Access Compliance Report Public Rights-of-Way (RR Crossings)

Intersection ID: 10035790	Main Street: REMOUNT_RD	Location:	N/A
ADA ID: 7FCDB128C925	Overall Compliance: No	Severity Score:	0.0
Codes/Mitigation Info/Possible Solution		Field Measurements/Component Compliance

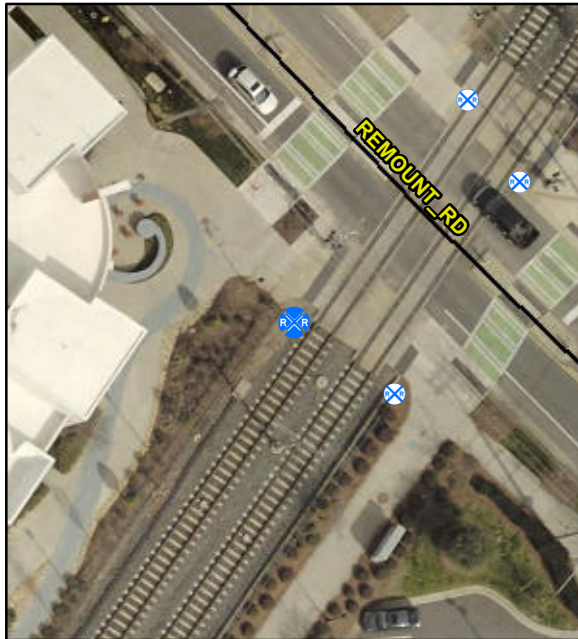
Remove & Replace Detectable Warning System. Provide Pedestrian Gate. Remove & Replace Walking Surface Adjacent to Rail.

R302.7.4, R305.2.5

Compliance	Description	Data
Yes	DWS Provided?	Yes
Yes	DWS Contrast?	Yes
Yes	DWS Width (in)	Yes
Yes	DWS Length (in)	36.0
No	DWS Offset (in)	39.0
No	Pedestrian Gate?	No
N/A	DWS Outside Gate?	N/A
N/A	Rail Type?	LightRail
No	Flangeway Gap (in)	3.0
Yes	Sidewalk Width (in)	91.0
